## PLANNING AND ZONING CASE CHECKLIST

**Project Number:** SP2019-006  
**Project Name:** Plaza at Rockwall  
**Project Type:** SITE PLAN  
**Applicant Name:** KIMLEY-HORN  
**Owner Name:** EXCEL, ROCKWALL LLC  
**Project Description:**

**TO:** Planning and Zoning Commission  
**DATE:** April 9, 2019  
**APPLICANT:** Marla Mauricio; *Kimley-Horn and Associates, Inc.*  
**CASE NUMBER:** SP2019-006; *Plaza at Rockwall*

**RE: AMENDING SITE PLAN (SP2019-006), Plaza at Rockwall**

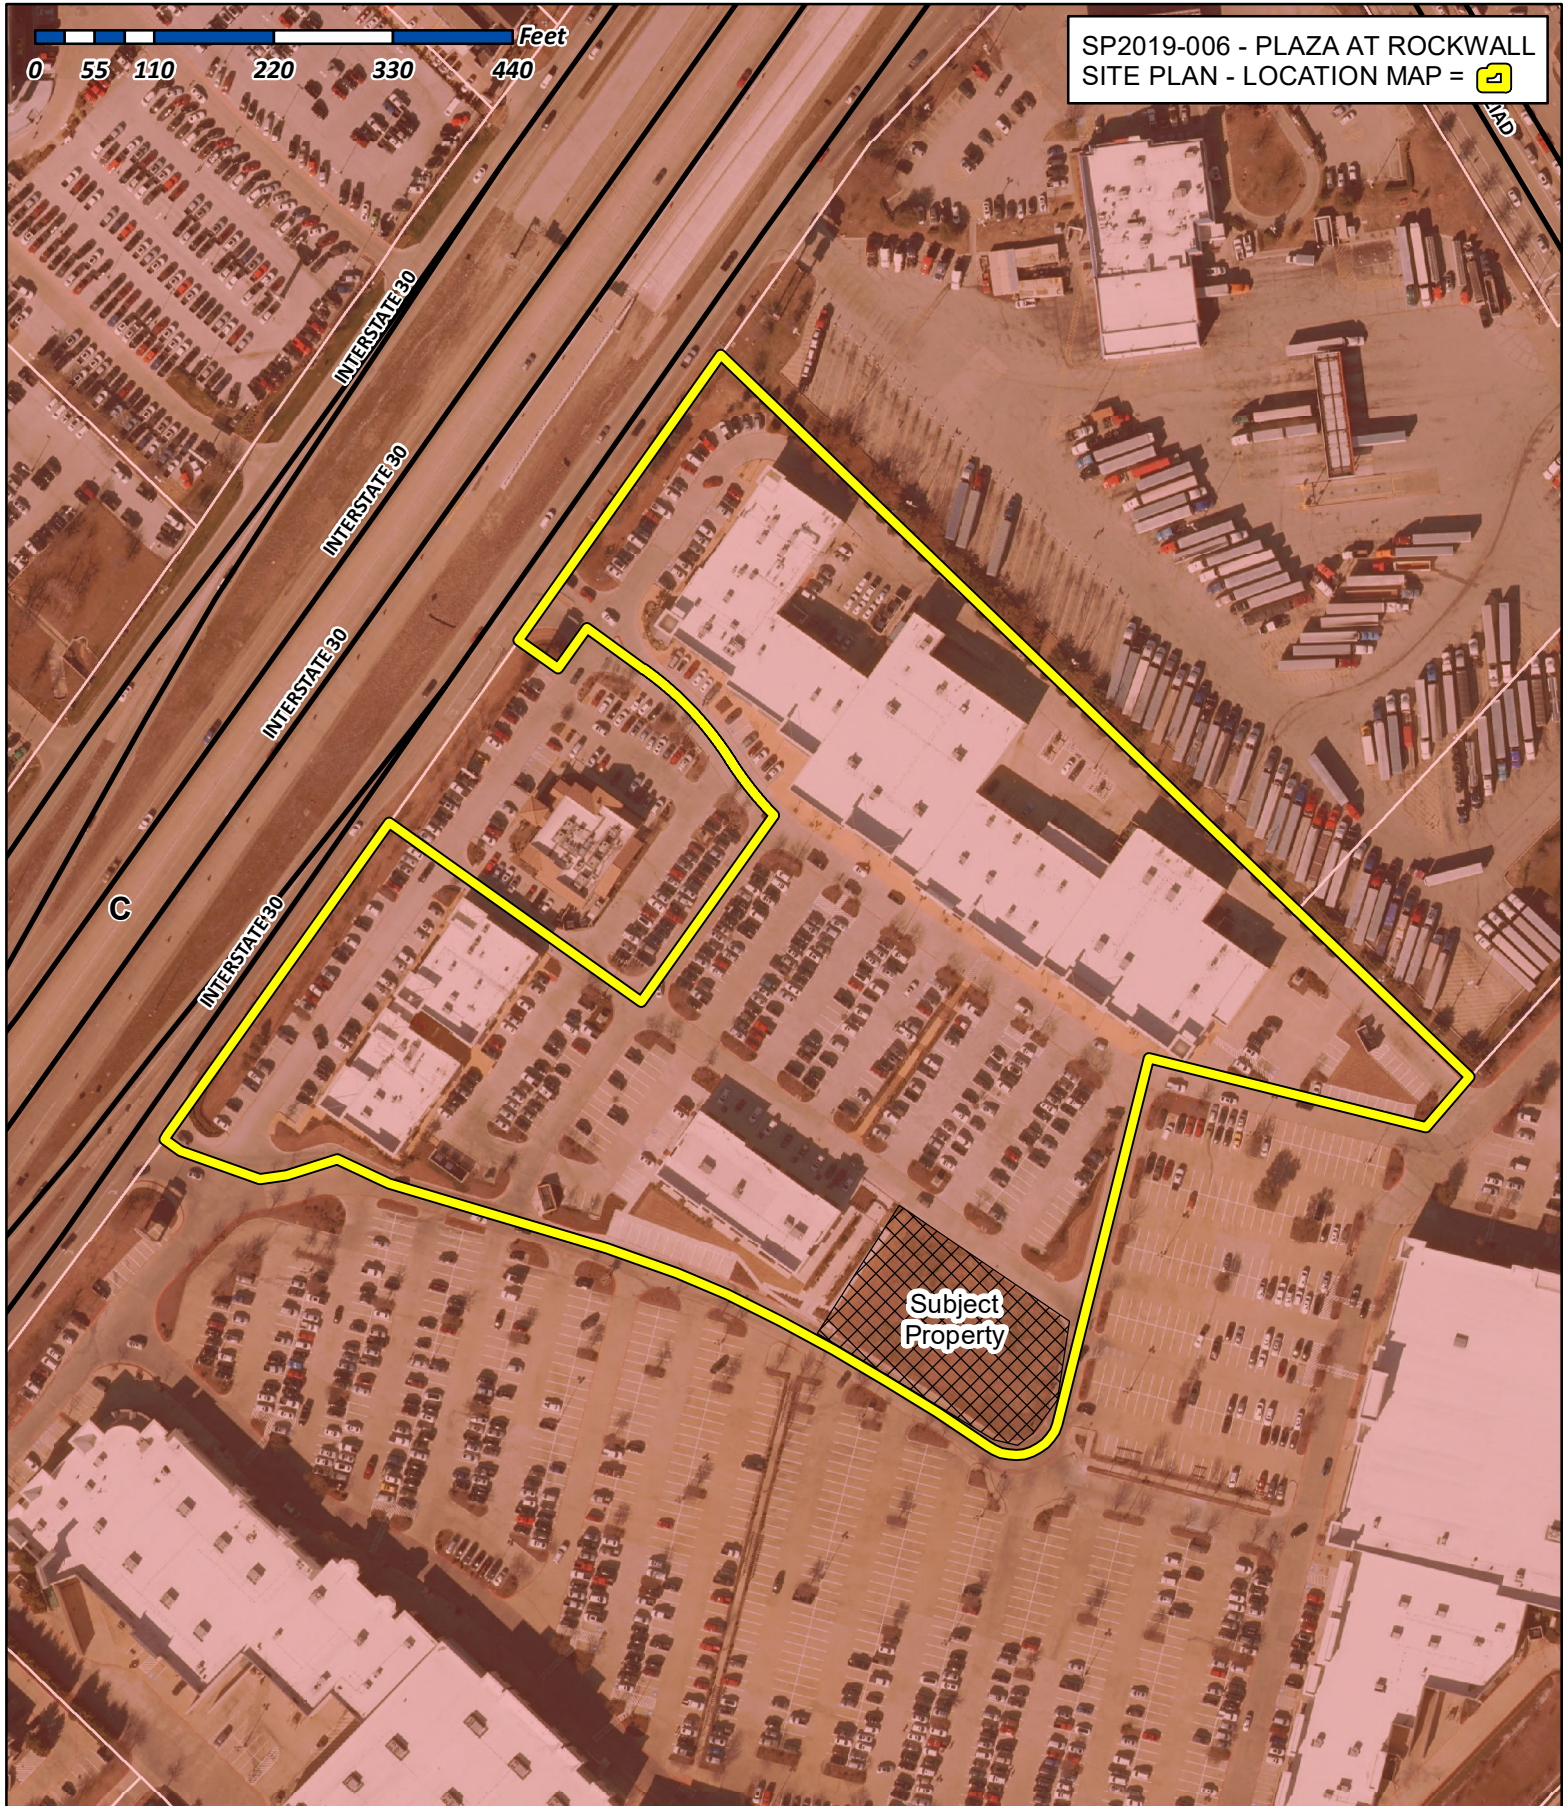
Type of Review / Notes	Contact	Sent	Due	Received	Elapsed	Status	Remarks
BUILDING	Russell McDowell	2/27/2019	3/6/2019	3/19/2019	20	APPROVED	
ENGINEERING (3/21/2019 4:29 PM SH) - 4% Engineering Fees - Impact Fees - Must replat to remove easements. - Walls 3' and over must be designed by an engineer. All retaining walls must be rock or stone face. No smooth concrete walls. - Show all utility relocations. - Where are you tying in the domestic meter? - Min 20' wide easements. - Must match existing drainage basins for Lot 10. - Dumpster to drain to an oil/water separator before going to the storm lines. - Include tree mitigation for trees in the breeze way. - Where the existing curbs are being cut, the cut must be 2' into the paving to prevent chipping later. - 3000psi (5.5 sack mix) 3600psi (6.5 sack mix) Rebar for concrete? - Must meet all City Standards of Design and Construction. - Note 4. on the landscape sheet should read, "No trees within 5' of utilities" - See mark up	Sarah Hager	2/27/2019	3/6/2019	3/21/2019	22	COMMENTS

FIRE	Kevin Clark	2/27/2019	3/6/2019	3/22/2019	23	COMMENTS	See comments

Type of Review / Notes	Contact	Sent	Due	Received	Elapsed	Status	Remarks
<p>(3/22/2019 1:21 PM KC)</p> <p>Fire sprinkler protection required for all buildings exceeding 5,000ft2, A2 Occupancies with an occupant load over 99, occupancy used for the manufacture and/or storage of upholstered furniture or mattresses exceeds 2,500 ft2.</p> <p>Size and location of the underground water line servicing the fire sprinkler system shall be indicated on the plans.</p> <p>The proposed location of the Fire Department Connection (FDC) shall be indicated on the plans. The FDC is required to be along the fire lane and within 100-feet as the hose lays, of a fire hydrant.</p> <p>Where a portion of the facility or building hereafter constructed or moved into or within the jurisdiction is more than 400 feet from a hydrant on a fire apparatus access road, as measured by an approved route around the exterior of the facility or building, on-site fire hydrants and mains shall be provided where required by the fire code official.</p> <p>Exceptions:</p> <p>(i) For Group R-3 and Group U occupancies, the distance requirement shall be 600 feet.</p> <p>(ii) For buildings equipped throughout with an approved automatic sprinkler system installed in accordance with Section 903.3.1.1 or 903.3.1.2, the distance requirement shall be 600 feet.</p> <p>Fire alarm sprinkler monitoring will be required for sprinkler system in shell building. Full fire alarm may be required depending on tenant and use of their space.</p>

GIS	Lance Singleton	2/27/2019	3/6/2019	3/20/2019	21	APPROVED	See comments
<p>(3/20/2019 8:41 AM LS)</p> <p>Address assignment will be:</p> <p>1041 E INTERSTATE 30, ROCKWALL, TX 75032</p> <p>All suites should follow a #110,120,130 or similar scheme. No letters.</p>							
PLANNING	Korey Brooks	2/27/2019	3/6/2019	3/21/2019	22	COMMENTS	Comments

Type of Review / Notes	Contact	Sent	Due	Received	Elapsed Status	Remarks
Considerations:						
<ul style="list-style-type: none"> <li>Bollards at or near the front of business to prevent a vehicle from intentionally or accidentally entering the front of the business. The bollards aesthetic(s) would be dictated by the business and city code(s).</li> <li>Assuming there are exterior receptacles (dumpsters and recycle) at the location. Receptacle Locations (Areas outside of the business) should be secured to prevent opportunities for criminal activity (Savaging). Prevention would include locking barriers (fencing) around receptacles and lighting to determine any criminals. The lower portion of fencing should be raised from the ground with enough clearance so that approaching employees would be capable of seeing if anyone is inside receptacle holding area prior to entering.</li> <li>Lighting around the rear of business should be within specifications dictated by city code and provide enough illumination to discourage anyone who does not have business at the location to leave the area.</li> <li>Soft, ground wash (Base of trees upward) lighting along rear tree lines to eliminate dark areas which could conceal someone.</li> </ul>

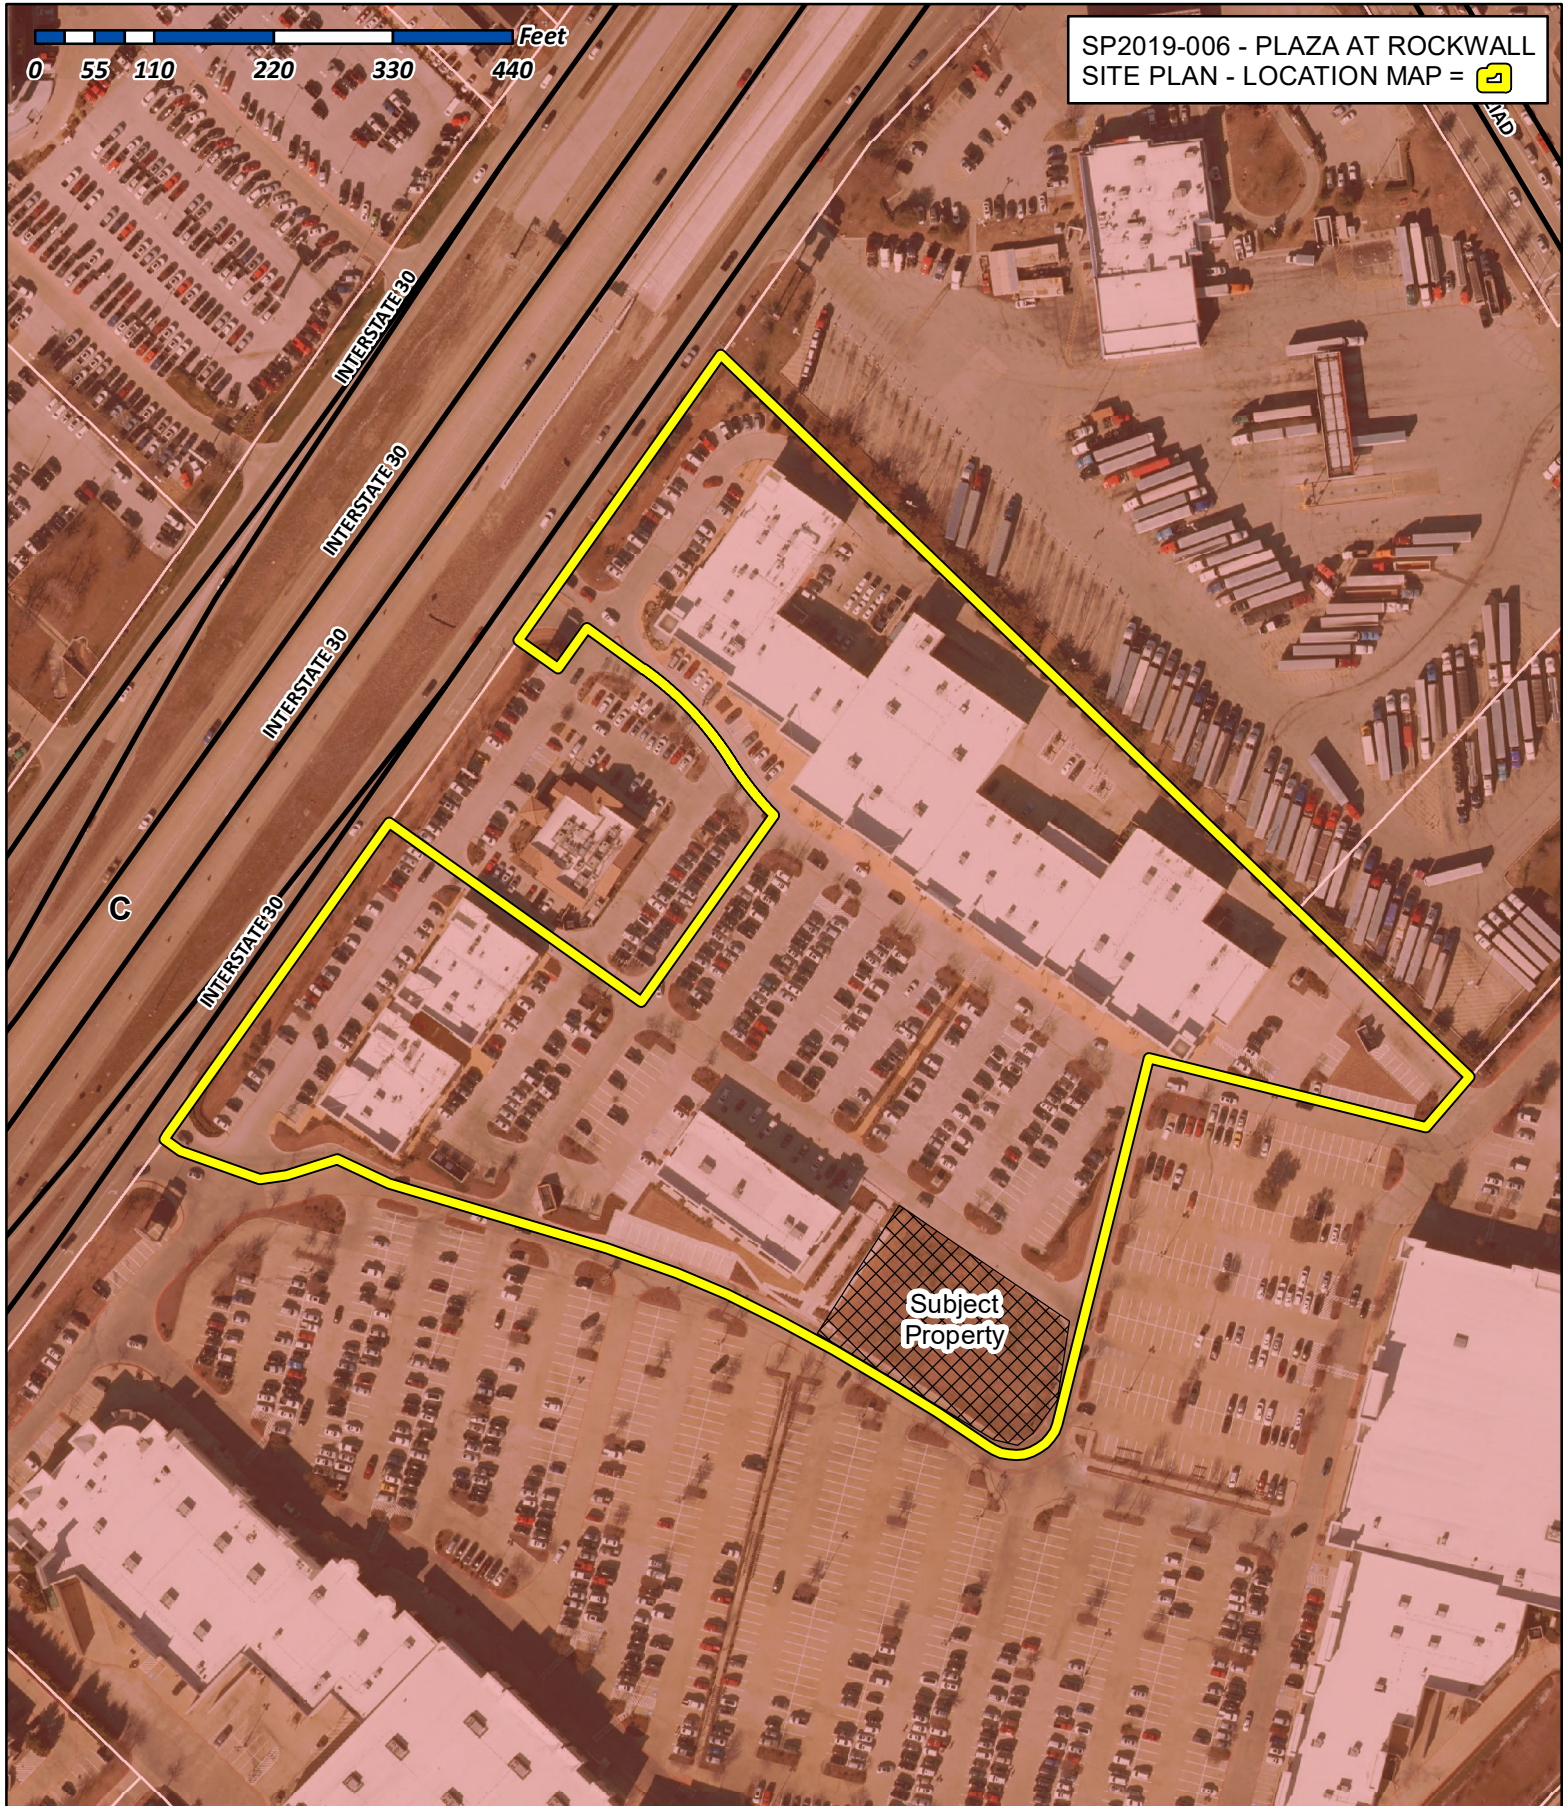
Type of Review / Notes	Contact	Sent	Due	Received	Elapsed	Status	Remarks
BUILDING	Russell McDowell	2/27/2019	3/6/2019	3/19/2019	20	APPROVED	
ENGINEERING (3/21/2019 4:29 PM SH) - 4% Engineering Fees - Impact Fees - Must replat to remove easements. - Walls 3' and over must be designed by an engineer. All retaining walls must be rock or stone face. No smooth concrete walls. - Show all utility relocations. - Where are you tying in the domestic meter? - Min 20' wide easements. - Must match existing drainage basins for Lot 10. - Dumpster to drain to an oil/water separator before going to the storm lines. - Include tree mitigation for trees in the breeze way. - Where the existing curbs are being cut, the cut must be 2' into the paving to prevent chipping later. - 3000psi (5.5 sack mix) 3600psi (6.5 sack mix) Rebar for concrete? - Must meet all City Standards of Design and Construction. - Note 4. on the landscape sheet should read, "No trees within 5' of utilities" - See mark up	Sarah Hager	2/27/2019	3/6/2019	3/21/2019	22	COMMENTS

FIRE	Kevin Clark	2/27/2019	3/6/2019	3/22/2019	23	COMMENTS	See comments

Type of Review / Notes	Contact	Sent	Due	Received	Elapsed	Status	Remarks
<p>(3/22/2019 1:21 PM KC)</p> <p>Fire sprinkler protection required for all buildings exceeding 5,000ft2, A2 Occupancies with an occupant load over 99, occupancy used for the manufacture and/or storage of upholstered furniture or mattresses exceeds 2,500 ft2.</p> <p>Size and location of the underground water line servicing the fire sprinkler system shall be indicated on the plans.</p> <p>The proposed location of the Fire Department Connection (FDC) shall be indicated on the plans. The FDC is required to be along the fire lane and within 100-feet as the hose lays, of a fire hydrant.</p> <p>Where a portion of the facility or building hereafter constructed or moved into or within the jurisdiction is more than 400 feet from a hydrant on a fire apparatus access road, as measured by an approved route around the exterior of the facility or building, on-site fire hydrants and mains shall be provided where required by the fire code official.</p> <p>Exceptions:</p> <p>(i) For Group R-3 and Group U occupancies, the distance requirement shall be 600 feet.</p> <p>(ii) For buildings equipped throughout with an approved automatic sprinkler system installed in accordance with Section 903.3.1.1 or 903.3.1.2, the distance requirement shall be 600 feet.</p> <p>Fire alarm sprinkler monitoring will be required for sprinkler system in shell building. Full fire alarm may be required depending on tenant and use of their space.</p>

GIS	Lance Singleton	2/27/2019	3/6/2019	3/20/2019	21	APPROVED	See comments
<p>(3/20/2019 8:41 AM LS)</p> <p>Address assignment will be:</p> <p>1041 E INTERSTATE 30, ROCKWALL, TX 75032</p> <p>All suites should follow a #110,120,130 or similar scheme. No letters.</p>							
PLANNING	Korey Brooks	2/27/2019	3/6/2019	3/21/2019	22	COMMENTS	Comments

Type of Review / Notes	Contact	Sent	Due	Received	Elapsed Status	Remarks
Considerations:						
<ul style="list-style-type: none"> <li>Bollards at or near the front of business to prevent a vehicle from intentionally or accidentally entering the front of the business. The bollards aesthetic(s) would be dictated by the business and city code(s).</li> <li>Assuming there are exterior receptacles (dumpsters and recycle) at the location. Receptacle Locations (Areas outside of the business) should be secured to prevent opportunities for criminal activity (Savaging). Prevention would include locking barriers (fencing) around receptacles and lighting to determine any criminals. The lower portion of fencing should be raised from the ground with enough clearance so that approaching employees would be capable of seeing if anyone is inside receptacle holding area prior to entering.</li> <li>Lighting around the rear of business should be within specifications dictated by city code and provide enough illumination to discourage anyone who does not have business at the location to leave the area.</li> <li>Soft, ground wash (Base of trees upward) lighting along rear tree lines to eliminate dark areas which could conceal someone.</li> </ul>
